**BULLETIN NO. 0901908**

**PRODUCT: 90 Series Boilers**

**TITLE: IGNITER CHANGE – PRODUCT IMPROVEMENT**

**PHOTO 2**  
**p/n 550002068**

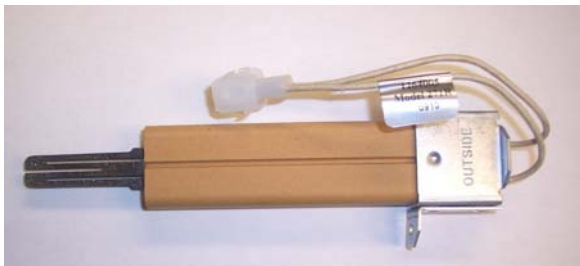
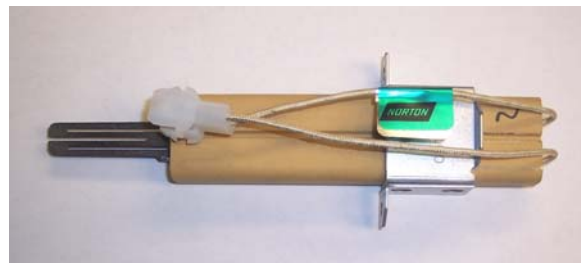
The igniter for the 90 series boilers has been redesigned to provide improved life expectancy. The change involved relocation of the mounting bracket thereby reducing the insertion depth. This allows the igniter to operate at lower temperatures while achieving the same flame signal. The bracket is offset from the end of the igniter by 1". Photo 1 depicts the original style igniter. Photo 2 is the newly redesigned igniter. The new igniter is a direct replacement and no modification or re-wiring is needed. The part number for the new igniter is 550002068.

The new igniter is on all production models starting 05/14/2009. You may continue to use existing inventory, or we will accept warranty return of any igniter you have in stock (p/n 2272133). Please contact the Customer Service Dept. at (800) 325-5479 to arrange for a warranty exchange.
